September 22, 2023

ADDENDUM NO. FIVE (5)

PROJECT: PV-TEC Building Remodel

DATE: JUL 23  
 DRAWING NO. **A7.2**  
 JOB NO. 2306  
 24 OF 49

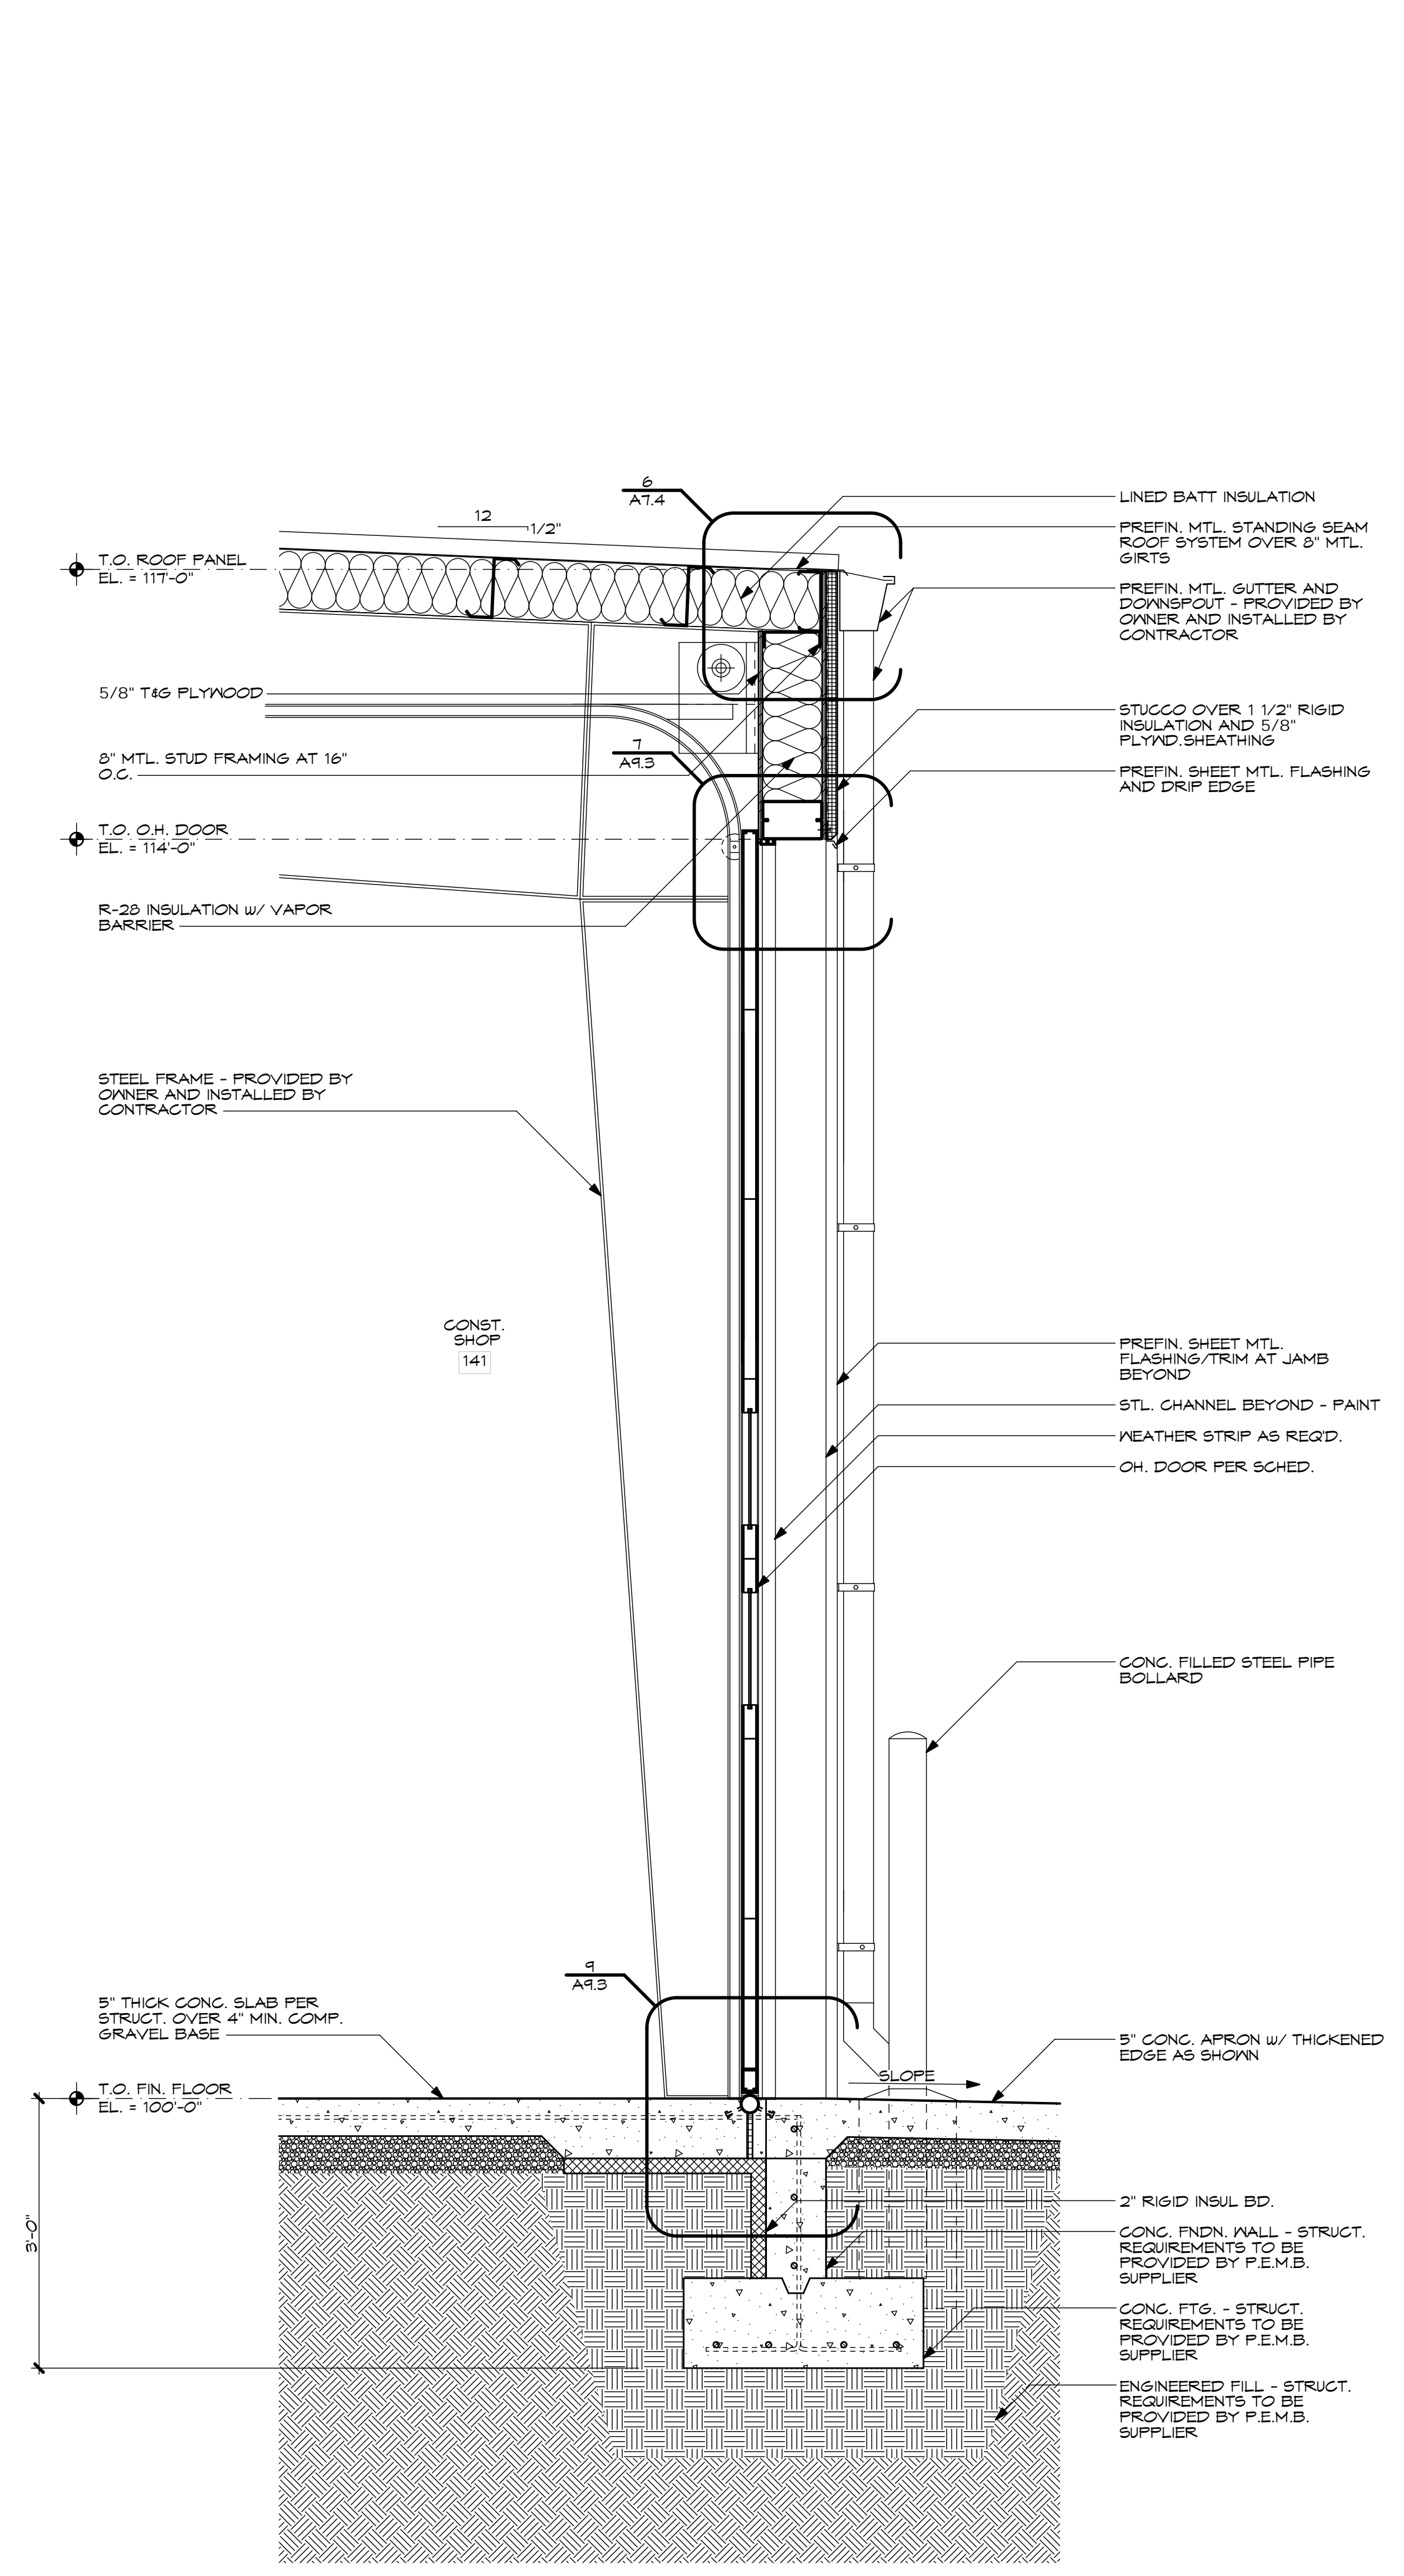
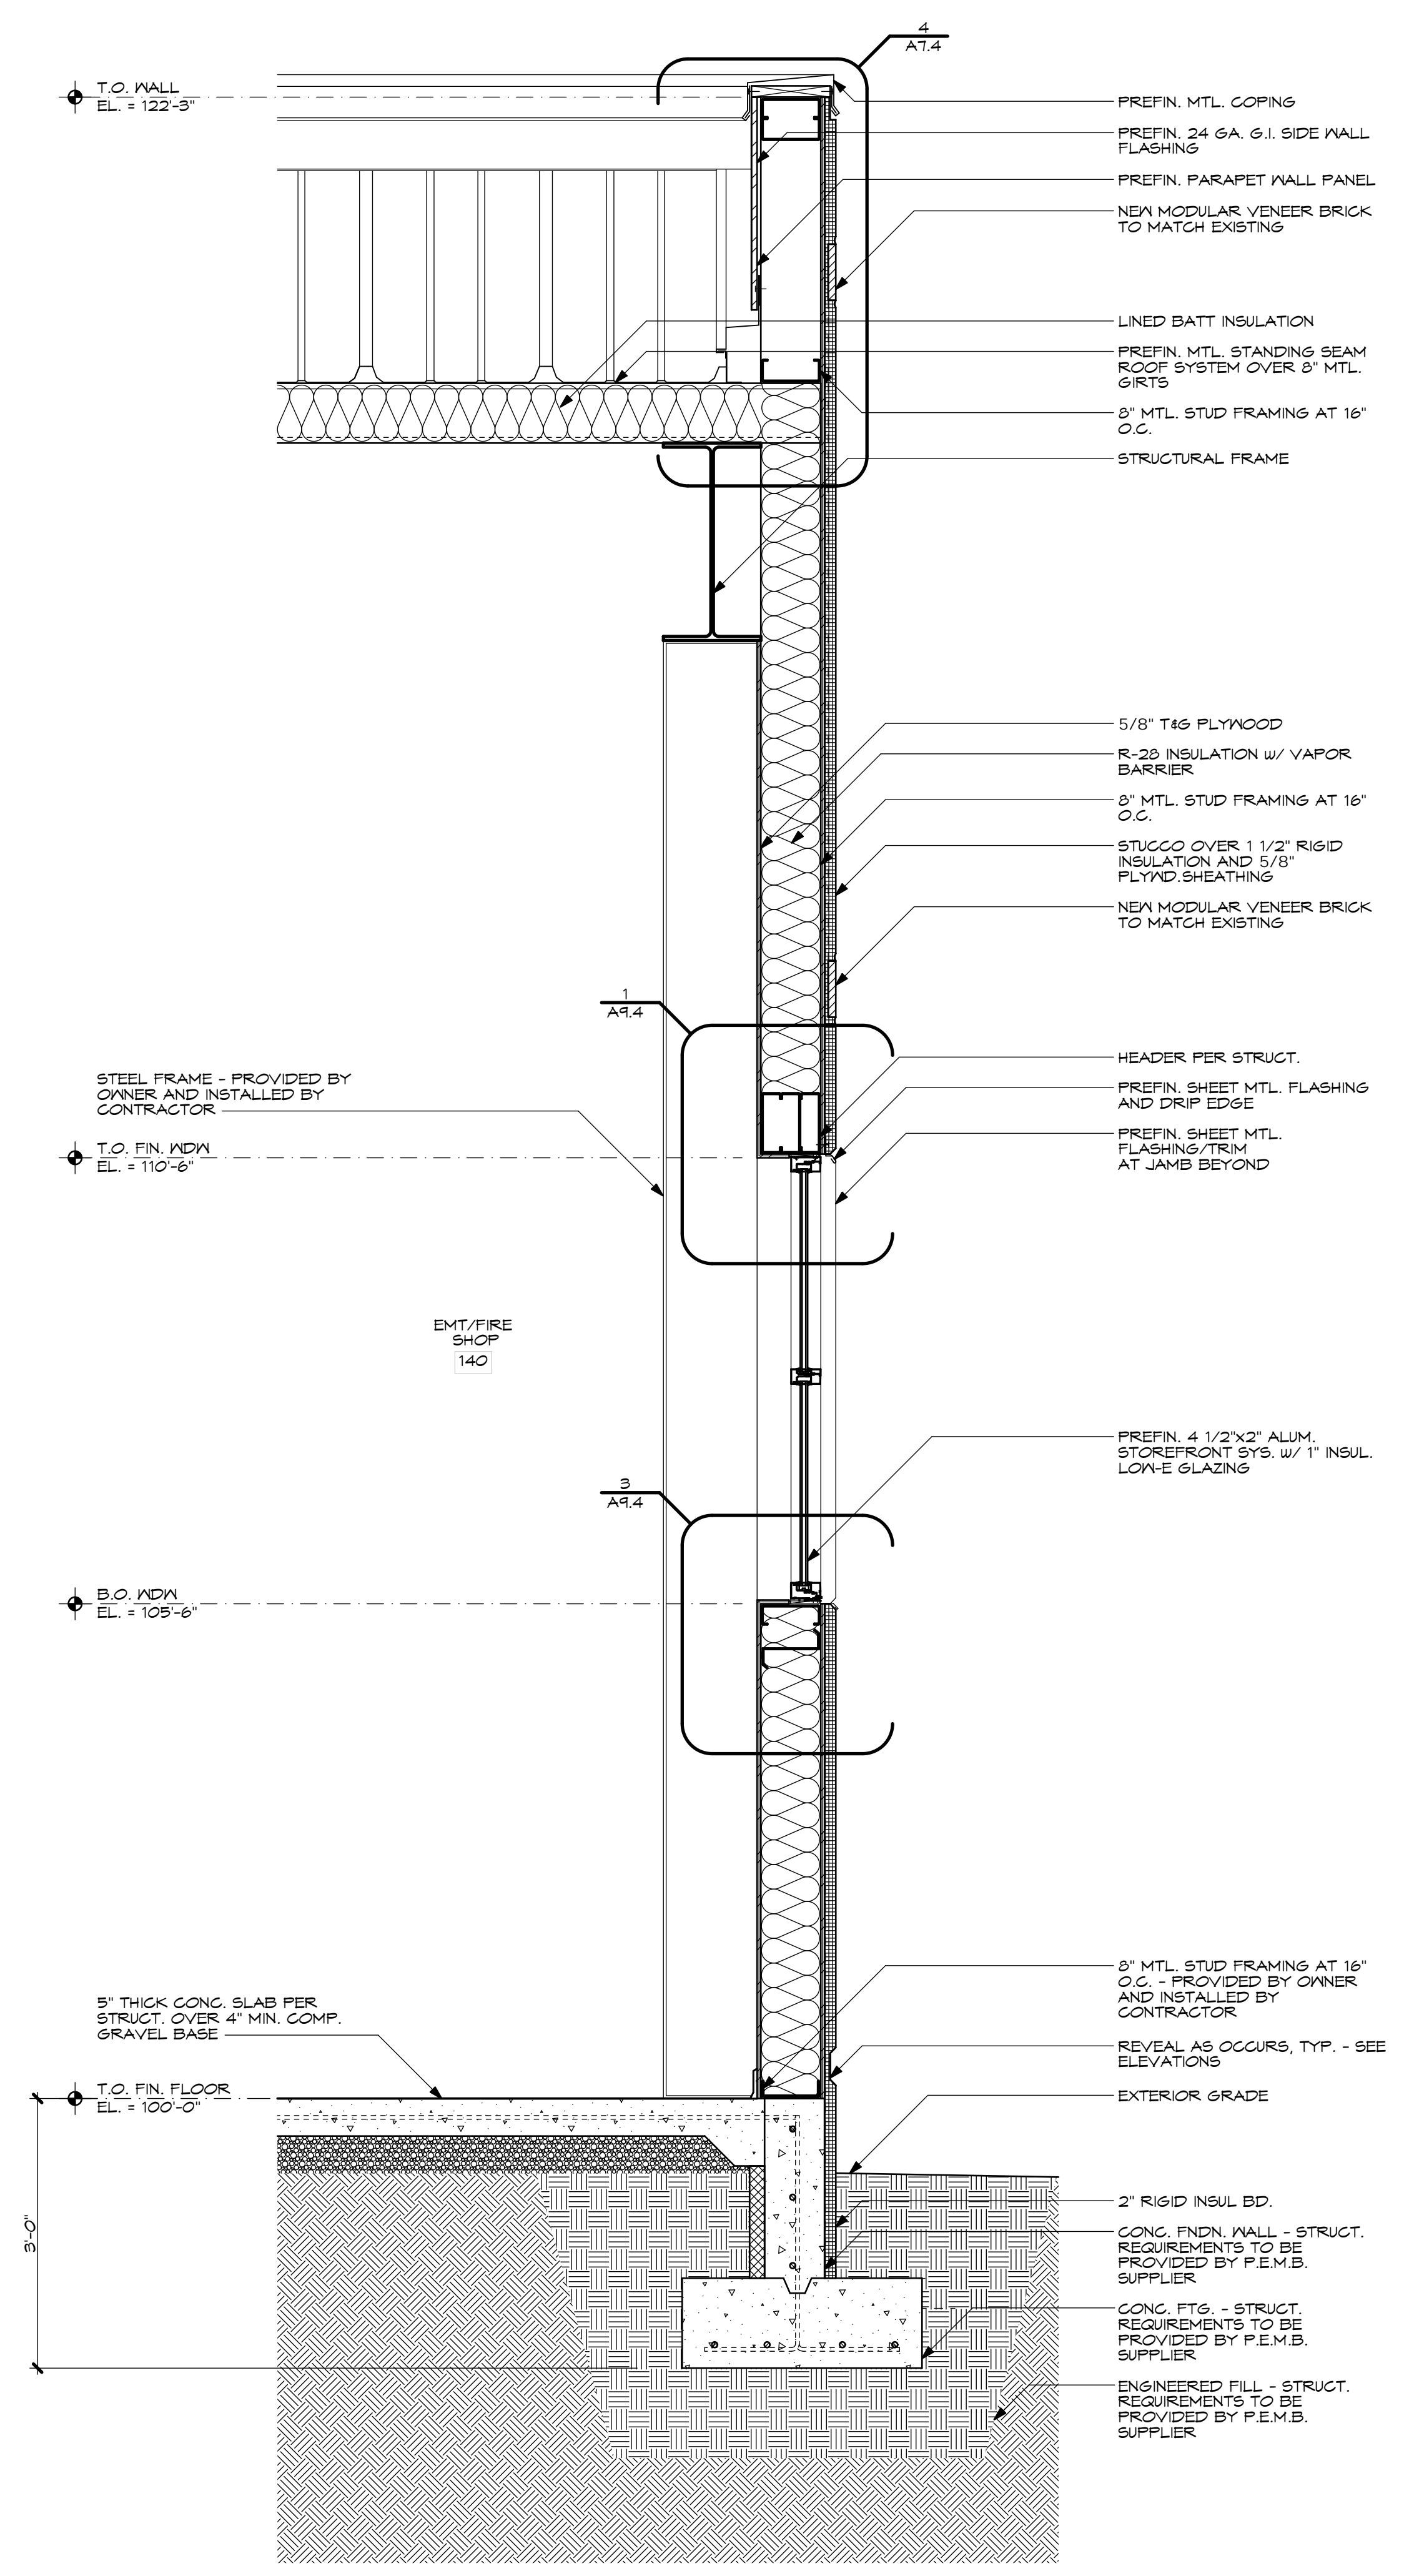
- D2 A7.1, A7.2 - Please see section details without girts to reflect there will NOT be any girts within exterior walls of addition.
- D3 A8.1, A8.2 – As a matter of clarification, the exposed structural framing and columns within the new building addition shall NOT be painted.
- D4 A8.1, A8.2 – As a matter of clarification, the sealed concrete shall comply to the following:
- Concrete Sealer: High-performance, non-yellowing, clear acrylic-based sealer  
Finish: Matte Finish
- D5 E2 Sheets – The “EX” labeled next to the fixtures in the ceiling are existing fixtures.
- D6 E6.1 – Provide and install line voltage (120 or 277) to each wireless light control. See attached sketch
